Pennsylvania Technical Advisory Committee Diesel Powered Equipment

Engine and Filter Evaluation

Duetz BF4M2012 (07-ENA040002)

Evaluation of the Nett technologies Diluter

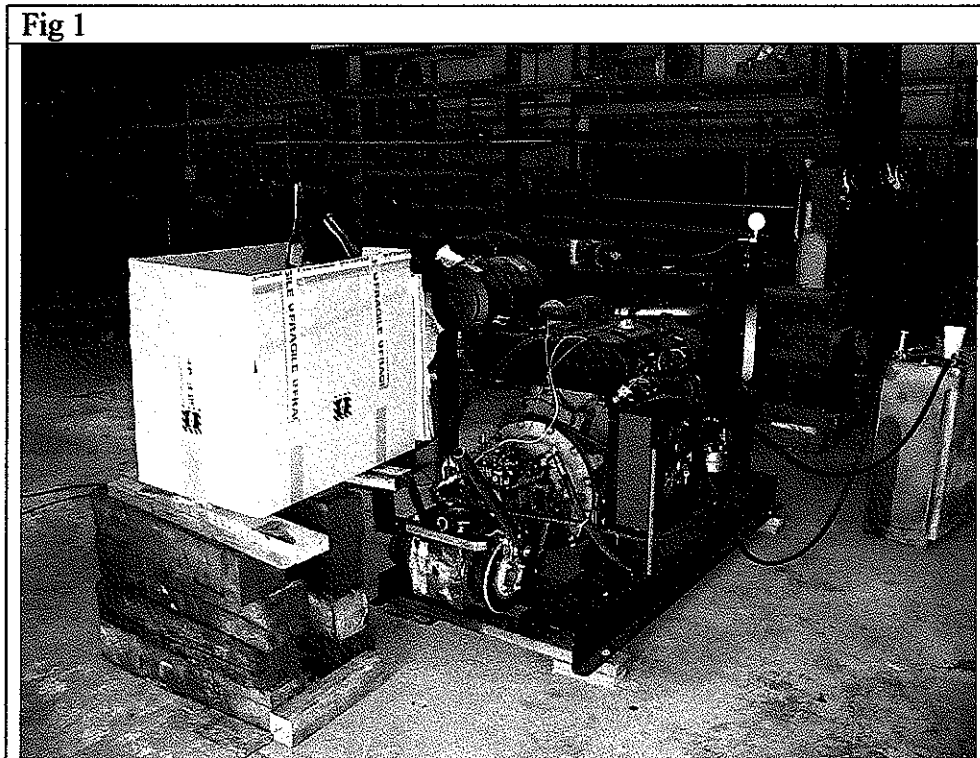
The purpose of the diluter is to mix ambient air with the exhaust to lower the temperature of the exhaust gas below the required 302⁰ F. The diluter was encased in a box to simulate the final configuration of this device (Fig. 1) The ambient air entering the box was measured with an anemometer during high idle condition. The amount of ambient air entering the box was found to be approximately 690 CFM. I believe this to be about a 1 to 1 ratio of exhaust and ambient air. We then attached a thermocouple probe (J configuration) to the diluter approximately ¾ of an inch into the exhaust stream (Fig.2). The test protocol used for this evaluation was as follows:

Fig. 2

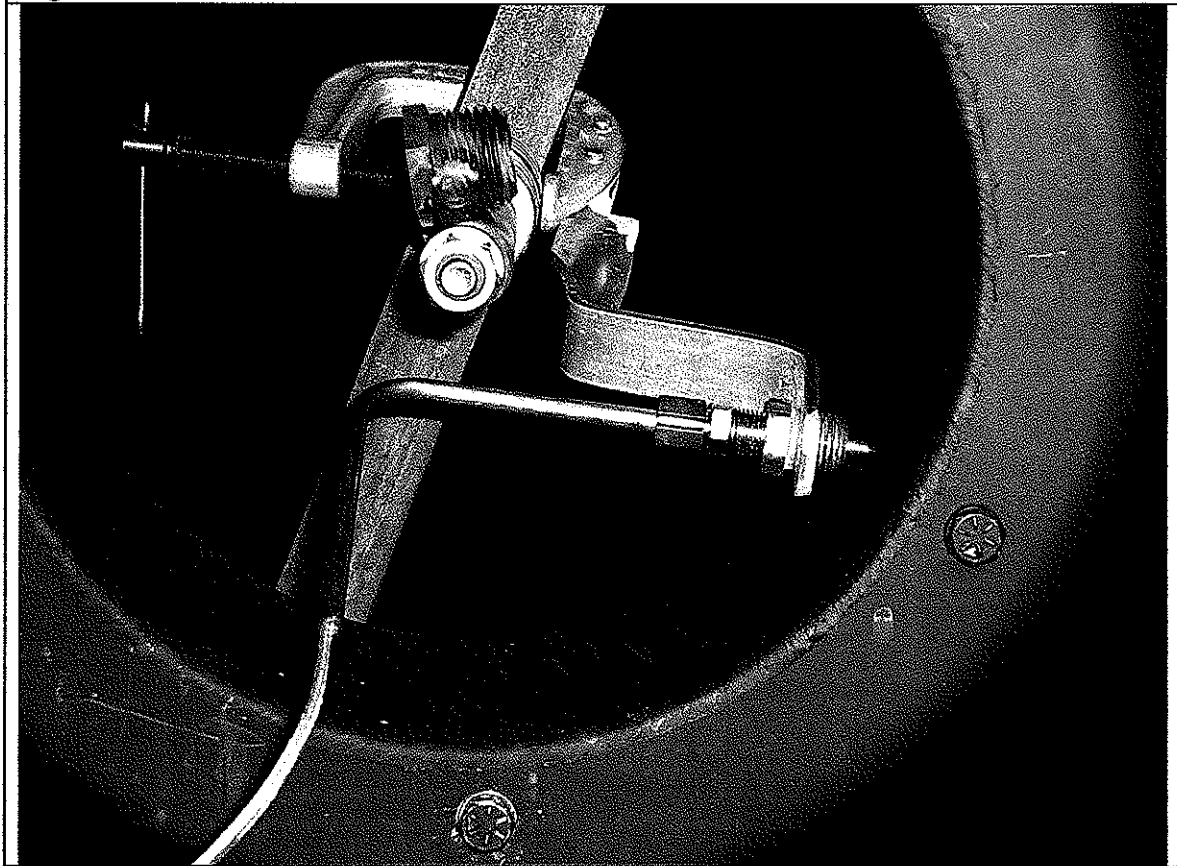
After the second series, the exhaust gas temperature increased above the 302⁰ F requirement (Chart 3). The test was stopped at this time. After studying the setup of the diluter we found that even though the thermocouple probe was located ¾ of an inch in by the outside edge of the diluter the position of the box caused the probe to be positioned 2 ½ inches in by the outer edge of the box. At this time we adjusted the thermocouple probe to be even with the outside edge of the diluter and approximately 1 1/2 inches into the exhaust stream. (Fig.3) We felt this would be acceptable since Pennsylvania law requires the exhaust gas to be under the 302⁰ F just prior to entering the mine

- It is clear that the position of the exhaust gas temperature shutdown will be critical to the use of this technology.
- If the probe is set too far in by the outer edge of the diluter it will not give an accurate reading of what the temperature of the exhaust gas is prior to entering the mine atmosphere.
- On the other hand if the probe is mounted beyond the outer edge of the diluter we would not be able to tell if the exhaust gas temperature requirement is being met.
- At this time I suggested that a small fan be installed that would increase the flow of ambient air into the diluter during periods of heavy duty cycle. I stated that it would not be necessary to have the fan run constantly but rather have the fan wired to turn on at about 250 degrees F. If this is done properly the Nett Technologies Diluter should meet all Pennsylvania requirements.

Fig.3

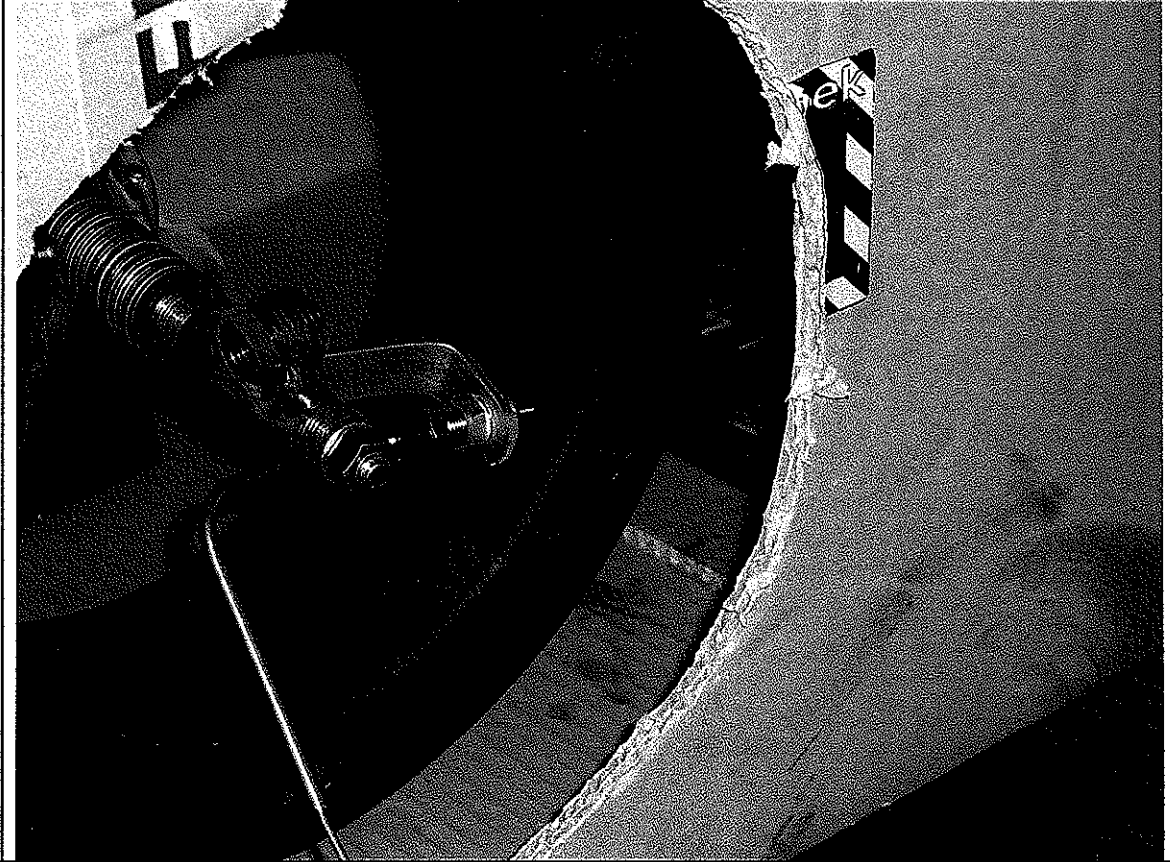
After adjusting the test protocol and the thermocouple, the test was restarted. The adjustment to the protocol did allow the transmission to undergo three successive stalls without critical over heating. The results of all testing can be seen in Chart 3.

Chart 3

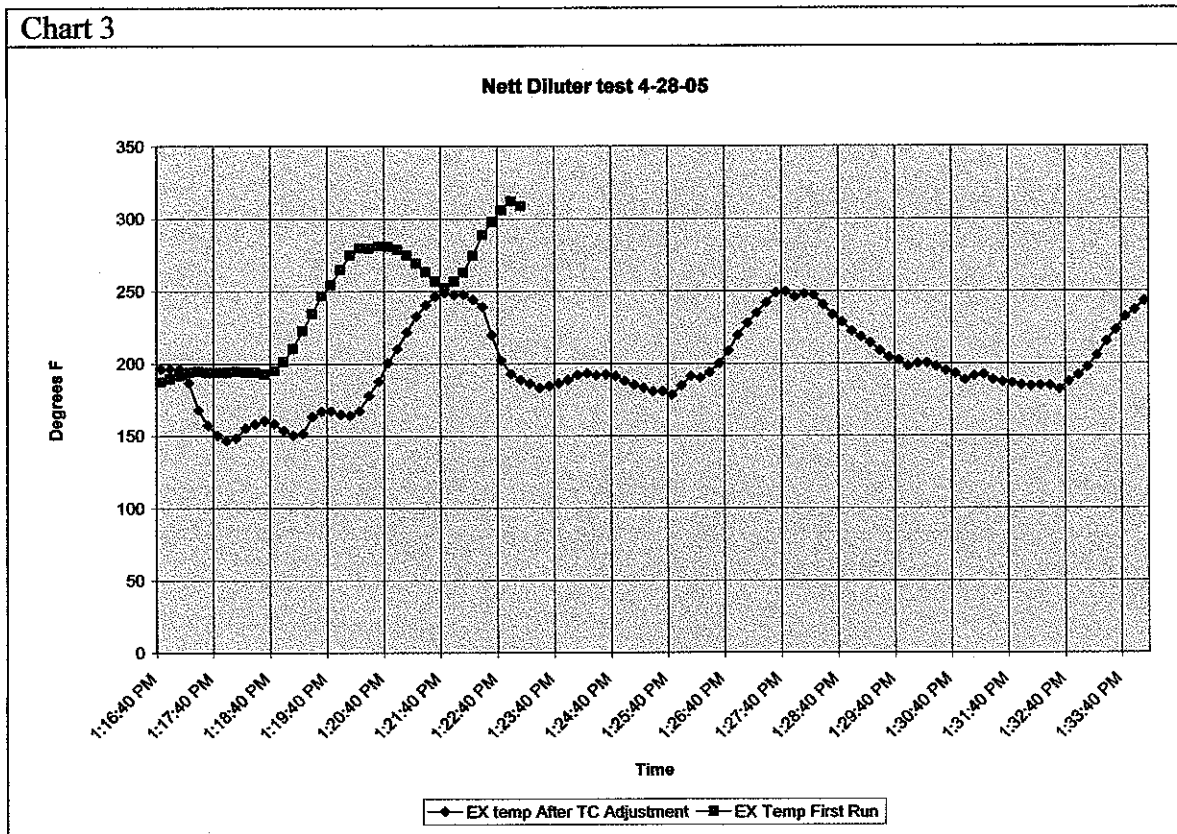
Unlike the first test, the diluter did maintain the exhaust gas below the Pennsylvania requirement during the entire test. (approx 17-minutes) The diluter seemed to set a trend during the testing with the high idle periods ranging from 167 to 192^o and stall condition ranging from 243 to 252^o F.

Although the TAC does believe the Nett Technologies Exhaust Gas Diluter (model 20) would meet the Pennsylvania requirement for exhaust gas temperature in the test configuration we can not, at this time, recommend the use of the diluter. The diluter will need to be set in its final configuration and further testing will need be performed. The TAC informed Hager Equipment that testing of the diluter in its final configuration would be needed before a final recommendation for its use in Pennsylvania could be made.
